CITY OF ALBUQUERQUE

RE: Kraemer Fields
2801 Karsten Court SE
Grading & Drainage Plan
Engineer's Stamp Date: 07/31/20
Hydrology File: M14D012J

Based upon the information provided in your submittal received 08/03/2020, the Grading & Drainage Plan **is not** approved for Grading Permit and Paving Permit. The following comments need to be addressed for approval of the above referenced project:

PROJECT NAME		PROJECT NO.	
KRAEMER FIELDS LOT 2A-1		19020	
DESIGNED BY:		RJF	
DRAWN BY:		RJS	
CHECKED BY:		RJF	
DATE:		JULY 2020	
SHEET TITLE		GRADING PLAN	
SHEET NO:		1

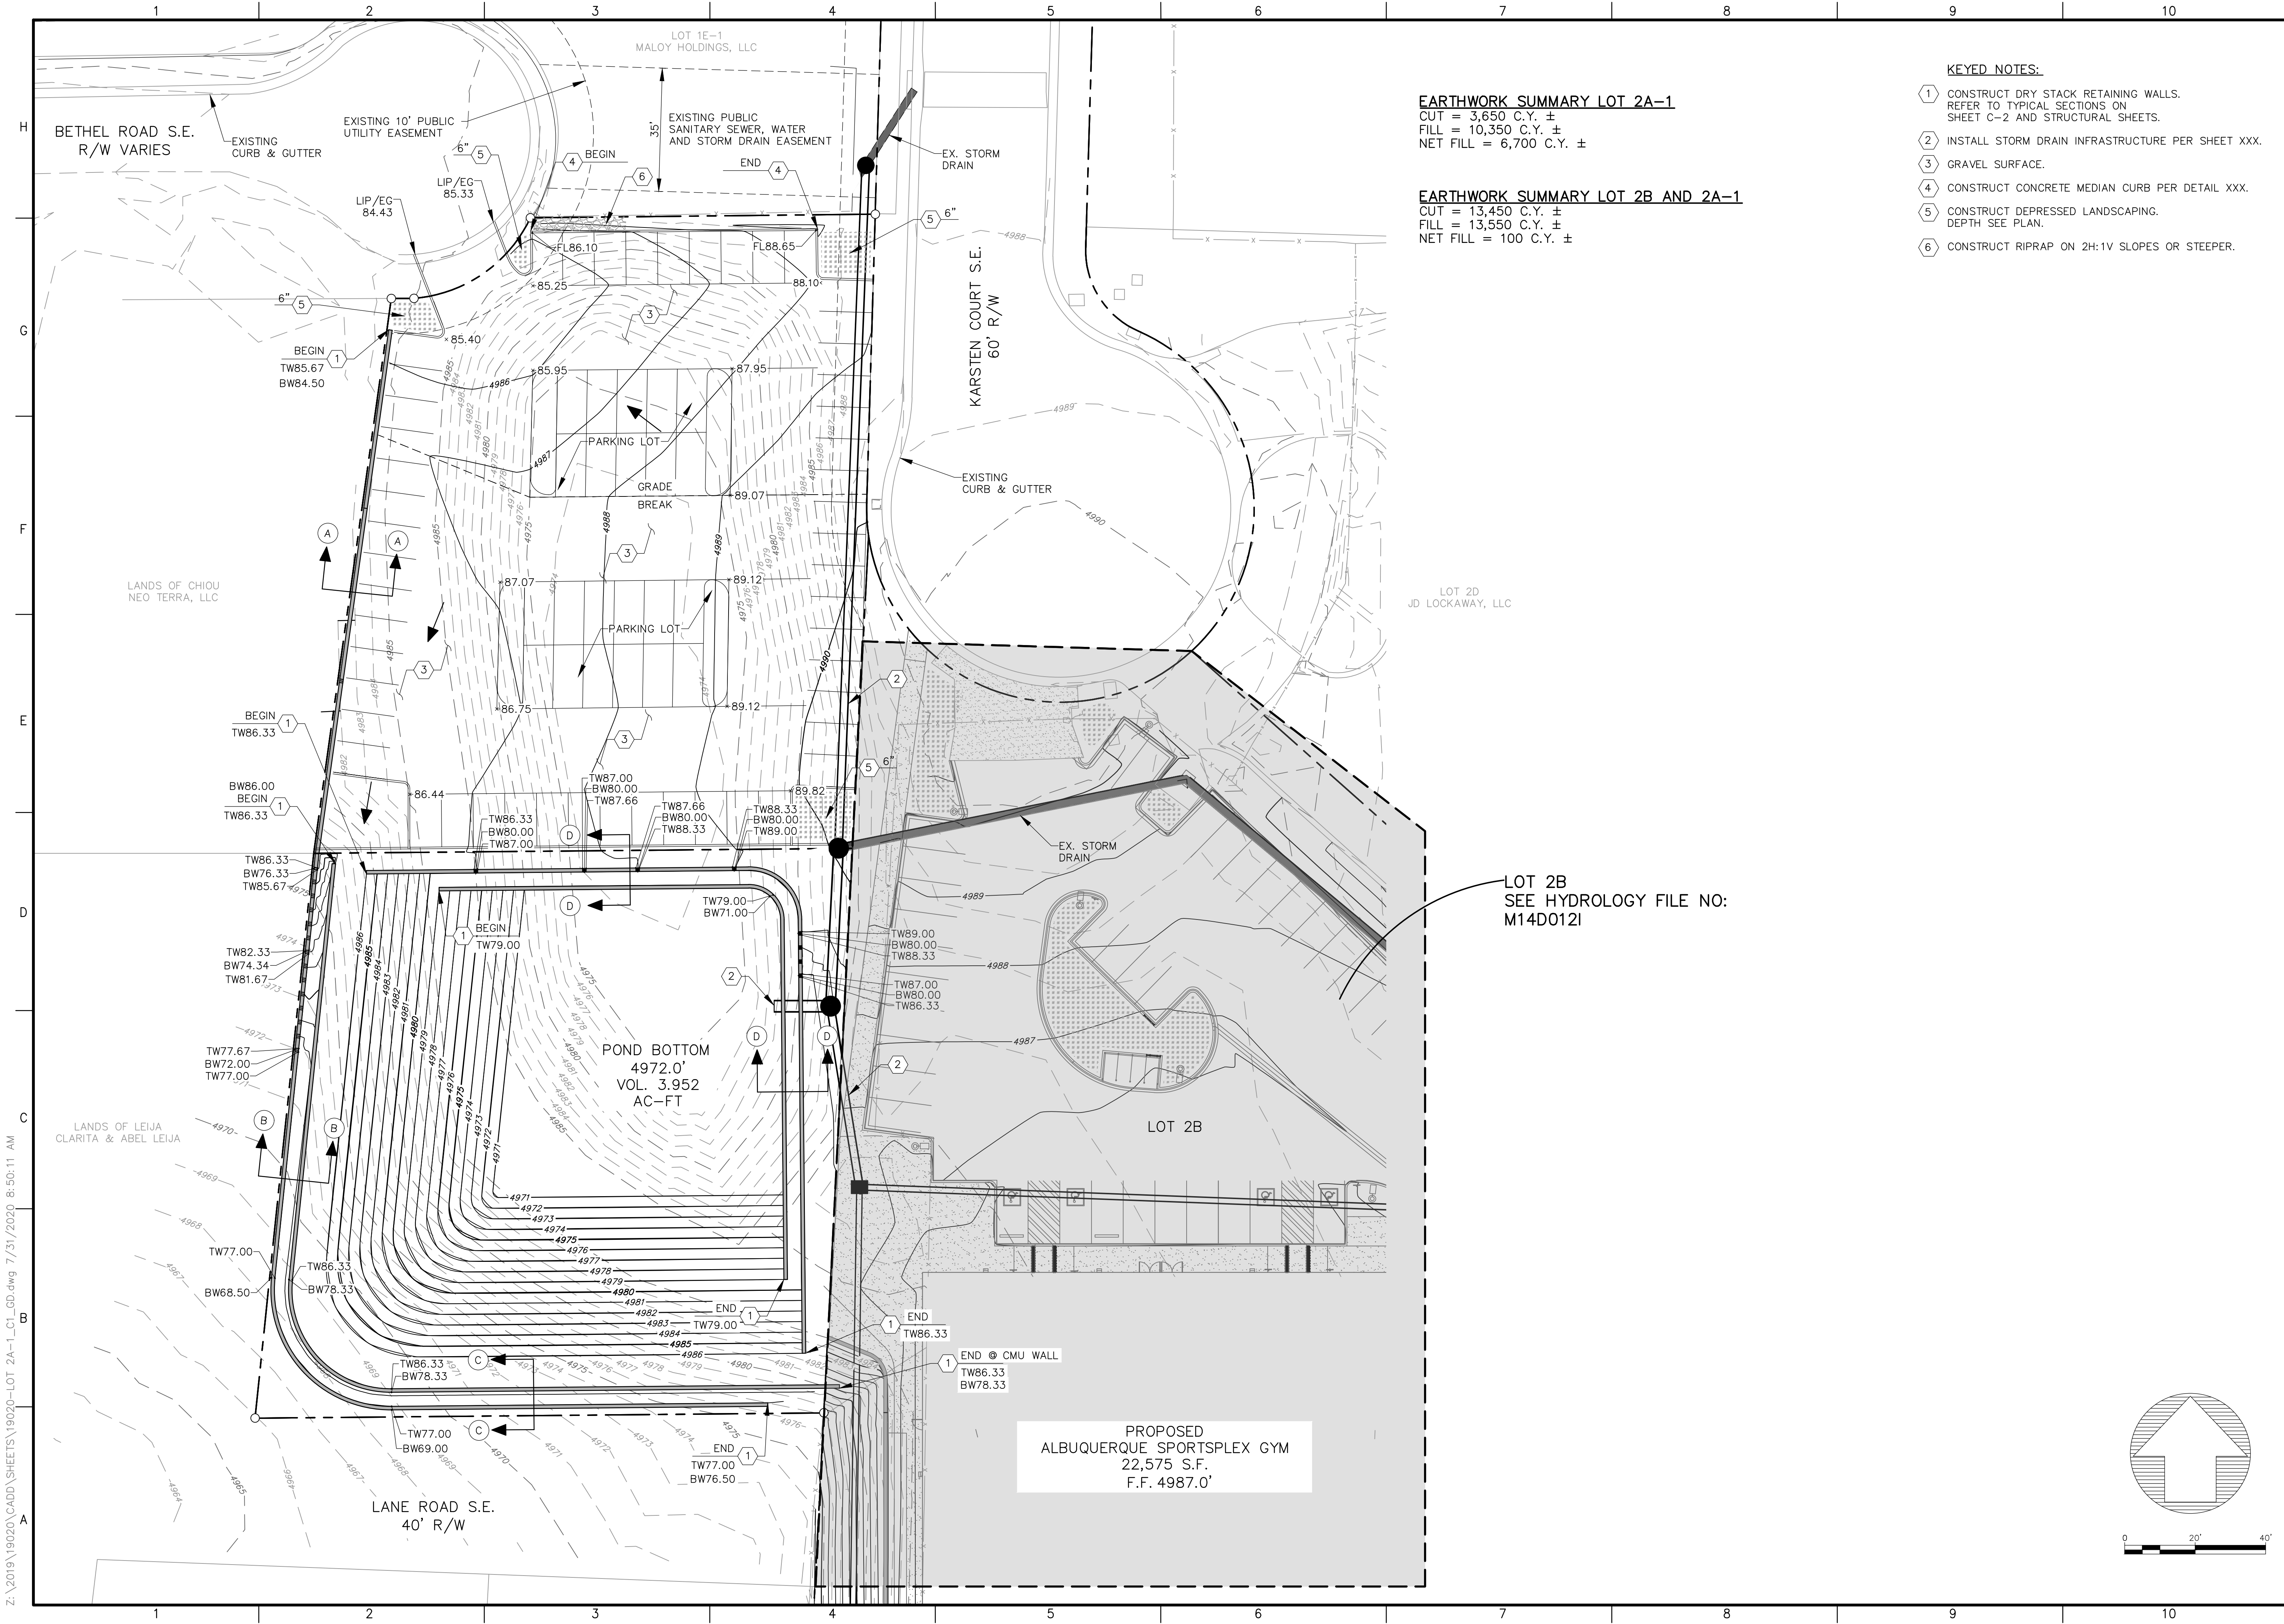
2. Sheet 1. Please correct the proposed ABQ Sports Complex drainage to reflect the approved Grading & Drainage Plan with Engineer's Stamp date of 11/14/19. Approval letter issued 11/21/19. (M14D012I). See below. If this site drains are being modified, than the Grading & Drainage Plan for this project ((M14D012I) will have to be resubmitted for approval by Hydrology.

3. Sheet 1. The proposed parking lot will not be able to street drain to Bethel Road. There is currently no capacity in the roadway to handle the runoff. Therefore you will need to install a water block per COA Paving Detail No. 2426 at the driveway entrance.

4. Sheet 1. The drainage from the proposed parking lot can be captured via storm inlet and connected to the proposed drainage system which outfalls to the newly shaped retention pond. This is what is indicated on Sheet 4.

5. Sheet 1. Please show the existing pipes that are to be removed and label them as being removed.
6. Sheet 1. Please provide all information on the proposed storm pipe system. (pipe invert elevations, MH top of rim elevations, inlet rim elevations,, and for the pipe sizes and lengths.

7. Sheet 1. Provide hydraulic calculations per Article 6-10 of the DPM for this proposed storm drain system, calculated along the Energy Grade Line; include both the HGL and EGLs in the table.

8. Sheet 1. Please provide a detail for the pipe outfall into the retention pond.
9. Sheet 2. Please provide the WSE of the 100 year 10 day volume in all sections.

DETAILS

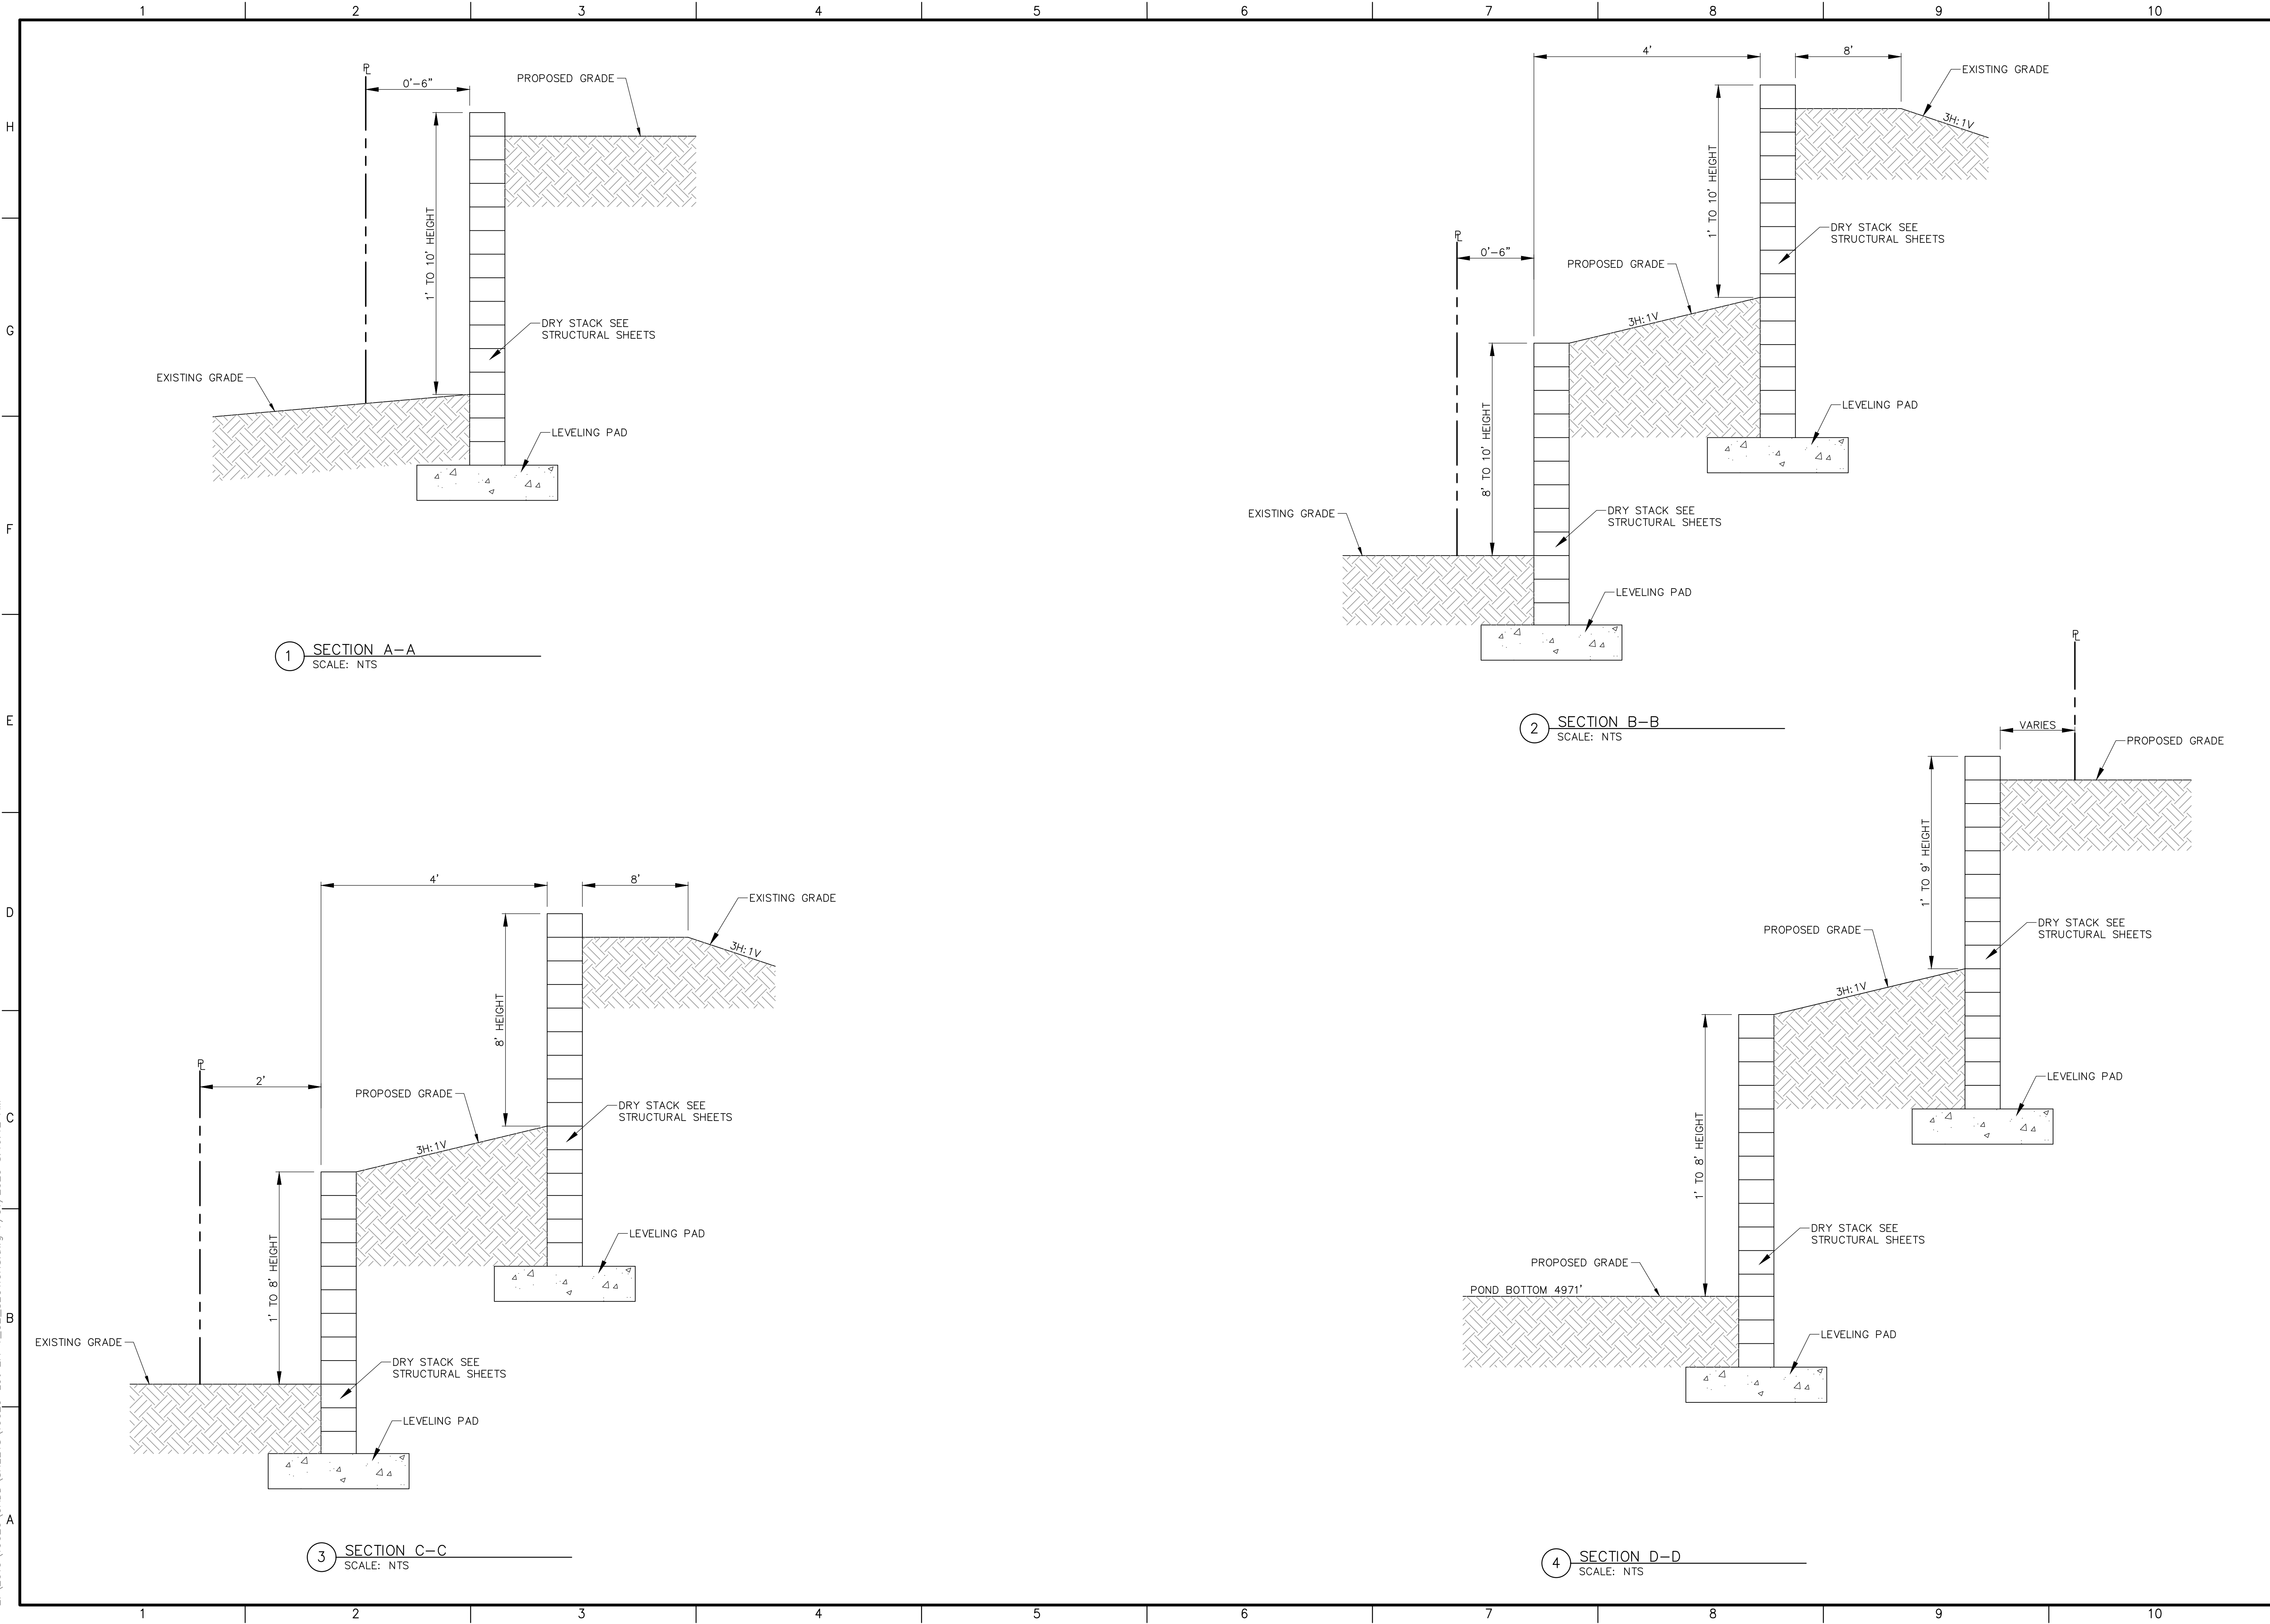
10. Sheet 2. .Please provide an approved City method to water proffing the retaining wall below the WSE of the 100 year 10 day volume.
11. Sheet 4. Basin 300 needs drain into the proposed storm drain as outlined in comment #4. Please show this.
